Access Compliance Report

Public Rights-of-Way

(Curb Ramps)

Intersection ID: 44958	Main Street: N_TRYON_ST	Cross Street: OLD_CONCORD_RD	Location: NW
ADA ID: 31C8D3A31675	Ramp Type: Perp	Initial Pass/Fail: Fail	Overall Compliance: No
Severity Score: 12.5			
Codes/Mitigation Info/Possible Solution		Field Measurements/Component Compliance

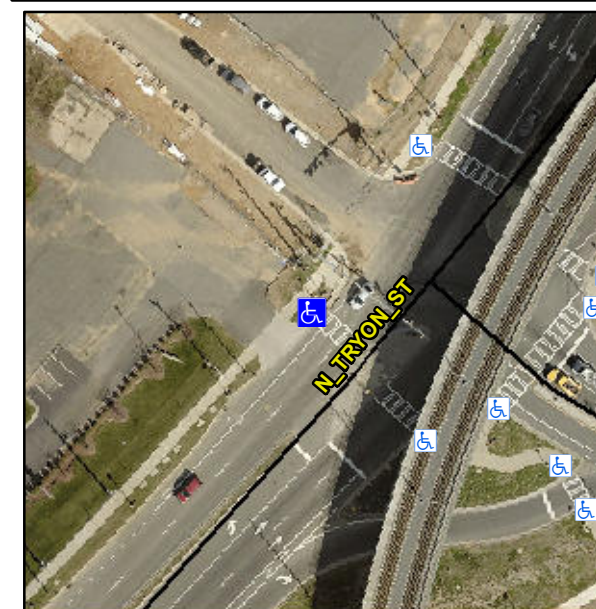
Not Found, R304.2.2

Compliance	Description	Data	Compliance	Description	Data
N/A	Ramp Length (in)	101.0	No	Ramp Slope (%)	8.7
Yes	Ramp Width (in)	95.0	Yes	Ramp XSlope (%)	1.5
N/A	Flare Type LT	N/A	N/A	Flare Type RT	N/A
N/A	Flare Slope LT (%)	N/A	N/A	Flare Slope RT (%)	N/A
N/A	Flare Traversable LT?	N/A	N/A	Flare Traversable RT?	N/A
N/A	Landing Length (in)	N/A	N/A	DWS Provided?	N/A
N/A	Landing Width (in)	N/A	N/A	DWS Contrast?	N/A
N/A	Landing Slope (%)	N/A	N/A	DWS Length (in)	N/A
N/A	Landing X Slope (%)	N/A	N/A	DWS Full Width?	N/A
N/A	Landing Curb? (Y/N)	N/A	N/A	DWS Offset (in)	N/A
N/A	Shared Landing?	N/A			
N/A	Gutter Ponding?	N/A	N/A	Gutter Slope (%)	N/A
N/A	Gutter Lip Ht (in)	N/A	N/A	Gutter X Slope (%)	N/A
N/A	Painted X Walk1?	Yes	N/A	Painted X Walk2?	N/A
	X Walk 1 Direction	To SE		X Walk 2 Direction	N/A
N/A	X Walk 1 Width (in)	120.0	N/A	X Walk 2 Width (in)	N/A
	X Walk 1 Slope (%)	2.4		X Walk 2 Slope (%)	N/A
	X Walk 1 X Slope (%)	1.6		X Walk 2 X Slope (%)	N/A

Remove & Replace Entire Ramp.
